Migration from MPC8313E Revision 1.0 to Revision 2.x

by *NMG Applications*
Freescale Semiconductor, Inc.
Austin, TX

Document Number: AN3545

Rev. 1
10/2008

Figure 1. Recommended Circuit for Disabling ECC Checking at Boot Up

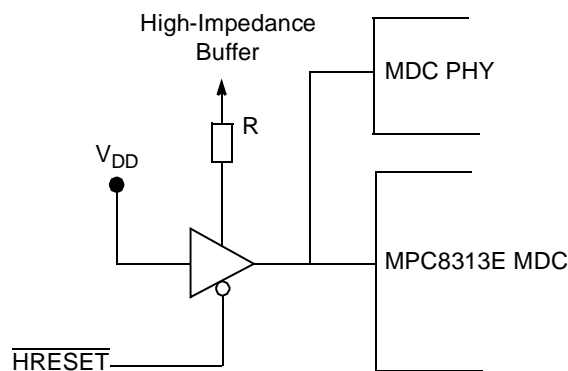
6.1 Option for ECC Disable for NAND Auto Boot

In revision 1.0, ECC checking was enabled by default, and no option was available for disabling or enabling it. In revision 2.x, an eLBC control signal, LB_POR_CFG_BOOT_ECC_DIS, has been added to enable or disable ECC checking during boot time. This signal is multiplexed on TSEC1_MDC as function 1. It will automatically be selected whenever $\overline{\text{HRESET}}$ is asserted; the pin will act as TSEC1_MDC at all other times. The reset block will sample this signal on $\overline{\text{PORESET}}$ negation only. The sampled value is then passed to the eLBC controller to enable/disable ECC checking during boot time. An internal pull down has been added to the TSEC1_MDC pin to enable ECC checking by default. After $\overline{\text{HRESET}}$ is negated the TSEC1_MDC function will be selected again. See Table 13 and Figure 1 for details. Note that in revision 1.0 ECC checking was also enabled by default; if disabling ECC checking during boot time is not required in revision 2.x, no hardware or software modifications are necessary.

To disable ECC checking on revision 2.x, use a high-impedance buffer on the board, as shown in Figure 1, to drive a strong pull up on the TSEC1_MDC pin while $\overline{\text{HRESET}}$ is asserted. If a strong external pull up of at least 1.5 k Ω on the TSEC1_MDC pin has already been added, but ECC checking during boot time is desired, a high-impedance buffer will need to be used to activate this external pull up only after $\overline{\text{HRESET}}$ is negated. If no change in ECC check enable/disable is intended, no changes are required. These options have been implemented on the revision 2.x RDB board with a dip switch, high-impedance buffer, and non-populated pull up on TSEC1_MDC.

New Feature Required (Ability to Disable ECC Checking)	Pull Up Exists on MDC	Pull Down Exists on MDC	Recommendations
No	No	No	No changes required
No	No	Yes	The external pull down will be in parallel to the internal 10k pull down. If the effective resistance becomes too low, it may hamper the TSEC1_MDC signal. It is recommended that the external pull down be removed.
No	Yes	No	Depending on the value of the external pull up, it may form a potential divider, which may be affected while booting and also on the TSEC1_MDS signal. It is recommended that the external pull up be removed.
Yes	No	No	Add circuit as shown in Figure 1 .
Yes	No	Yes	Remove pull down and add the circuit as shown in Figure 1 .
Yes	Yes	No	Isolate pull up with high-impedance buffer as shown in Figure 1 .
